AERONAUTICAL CHARTING MEETING
Instrument Procedures Group
Meeting 22-02 – October 24-25, 2022

RECOMMENDATION DOCUMENT

FAA Control # 22-02-370

Subject: 8260.3E Figure 2-7-2 Misleading

Figure 2-7-2. Simple Restricted Circling Area

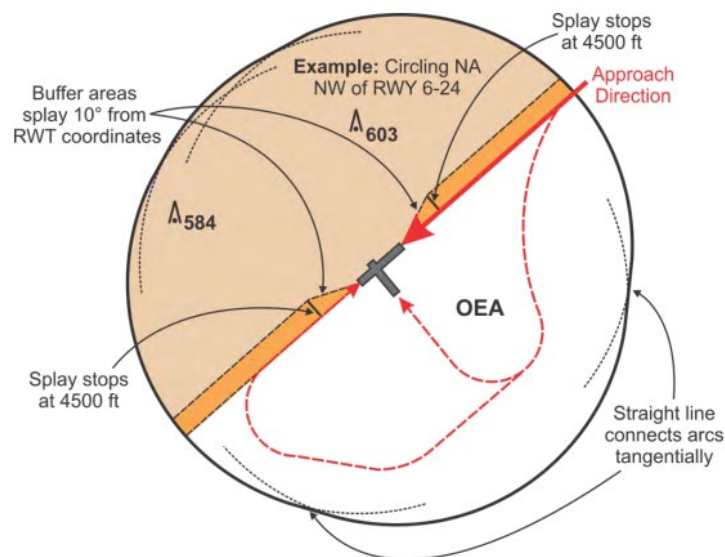
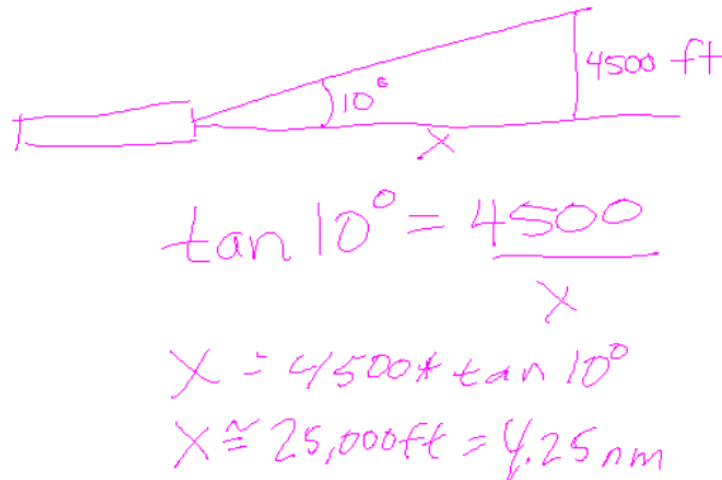
Figure 2-7-2 is at issue because it suggests the splay ends well within the circling area; however, applying the text-described formula leads to the splay stopping 4.25nm from the LTP,

Thus, the image in 2-7-2 is misleading because splay, all the way up to Category D below 7000ft MSL, extend to the edge of the circling area.

A cursory glance at figure 2-7-2 may lead one to assume the splay stops 4500ft away from the LTP.

Updated 8260.3E with a diagram more representative of the splay geometry.

Initial Meeting 22-02: Dr. Bill Tuccio, Garmin, briefed the issue from the RD ([slide](#)). The main issue is not the accuracy of the textual information but that the figure seems to be an inaccurate representation of the splay geometry. Dan Wacker, FAA Flight Procedures and Airspace Group (FPAG), voiced that the text correctly explains the intent. He pointed out the diagram is to help

visualize the area, noting he was not aware of any problems caused by the diagram and does not see a concern. Dan said he will look at either fixing or deleting the figure and does not see a need to track this in the ACM. Dan added there are many figures that may need revision throughout the orders and requested they be sent to him as identified. Jeff said the issue will be reviewed by the ARRG.
